**CITY OF CARMEL-BY-THE-SEA
PLANNING COMMISSION
AGENDA**

January 9, 2013
Wednesday
Tour – 2:45
Meeting – 4:00 p.m.

**CITY OF CARMEL-BY-THE-SEA
PLANNING COMMISSION – MINUTES
DECEMBER 12, 2012**

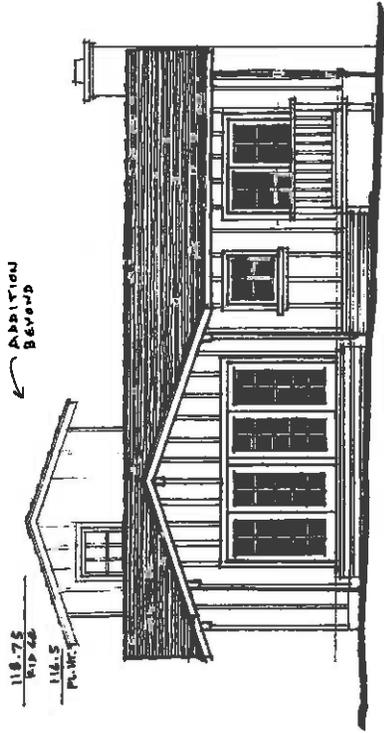
Using the requirements of CMC 17.06 for the subject property, the rear 26 feet of the property would be deducted out of the buildable area. As a result the allowed floor area would be reduced from 2,239 square feet to 2,000 square feet. Implementing this section of the Code would not impact this project, but it would put the residence near its maximum floor area with the proposed additions. Staff is using this project as opportunity to discuss some of the issues with the above code sections so that the Commission can determine what the allowed floor area should be on this property and others properties as well.

According to CMC 17.06, if the slope is greater than 30% and occupies 10% or more of the site then it should be deducted out the buildable area. The primary issue with implementing this requirement is that there is no description as to how the 10% measurement should be taken. With the subject project there is a well defined and continuous area at the rear of the property that clearly exceeds 30%. However, with many other properties measuring the boundaries of the 10% area may not be well defined, which could significantly affect the results. A visual demonstration of this issue will be provided at the hearing.

Another issue is that the above code sections are inconsistent with each other. CMC 17.06 states areas of 10% or greater with a slope of greater than 30% need to be deducted out the buildable area, while 17.10 states that if the entire property has a slope over 30%, then the site is still buildable but the floor area shall be reduced by 2% for every 1% increase in slope.

As of now it appears that the applicant would be required to deduct the rear 26 feet out of the buildable area. However, the Commission should discuss the issues raised in this staff report and could make a decision that only the slope of the entire property should be evaluated to provide better consistency and a more practical method for evaluating the slope.

CONGLETON
12/27/12
②

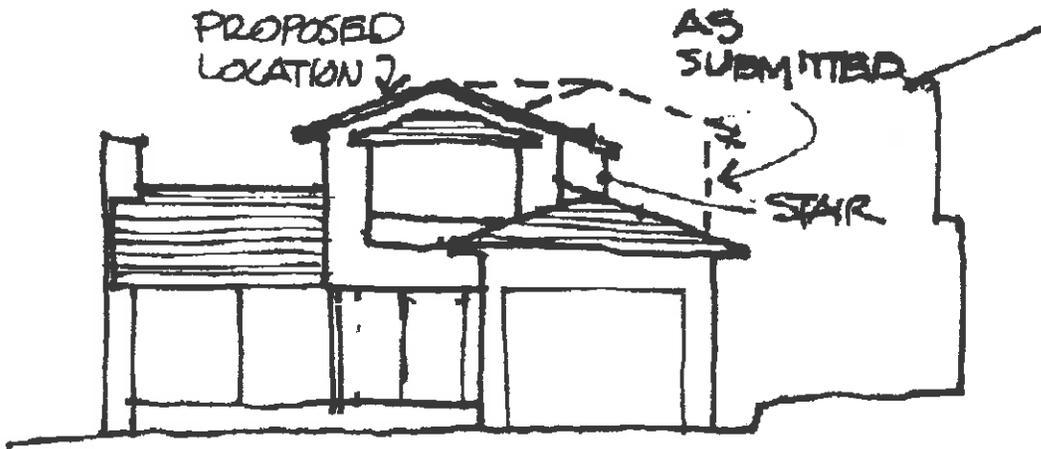
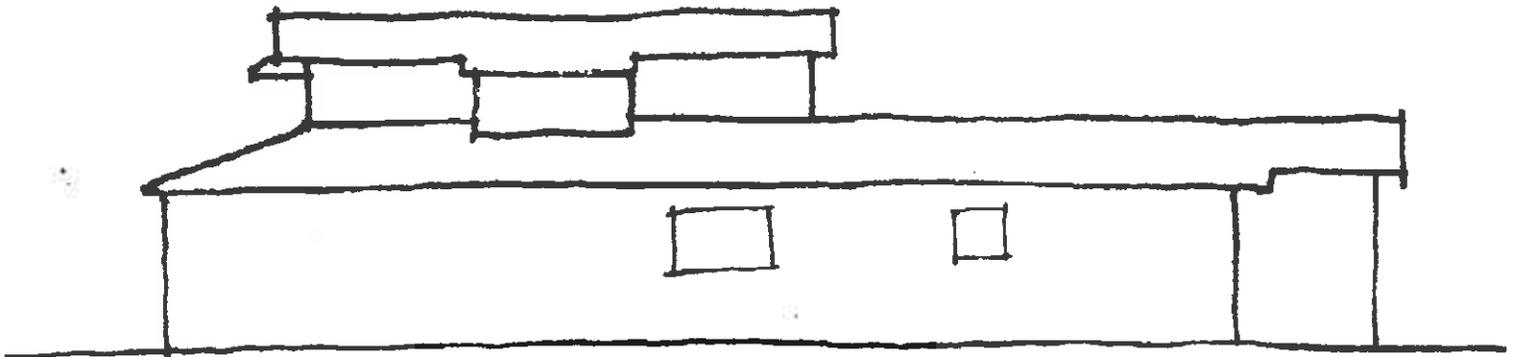
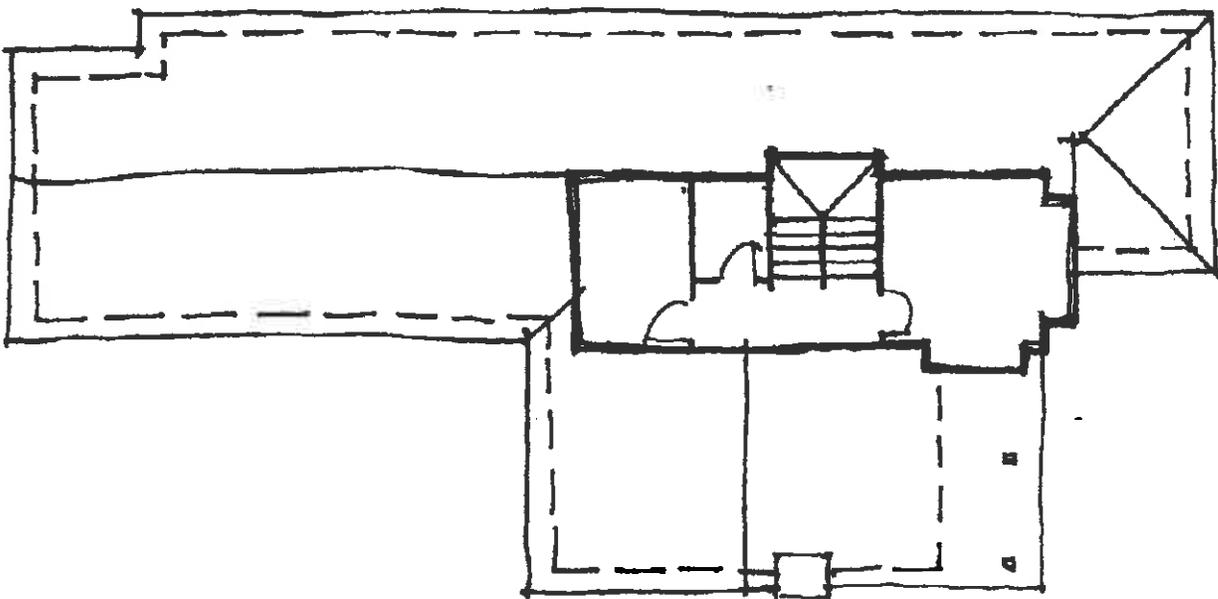
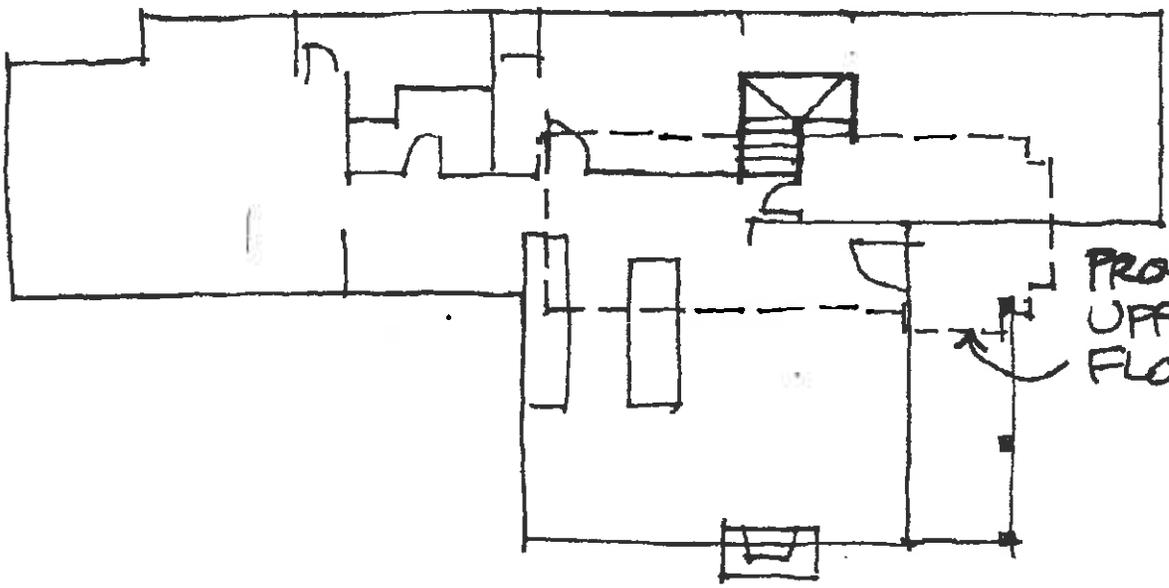
You and I discussed several possible locations for your neighbor to add to his house with minimal impact on the critical areas noted above:
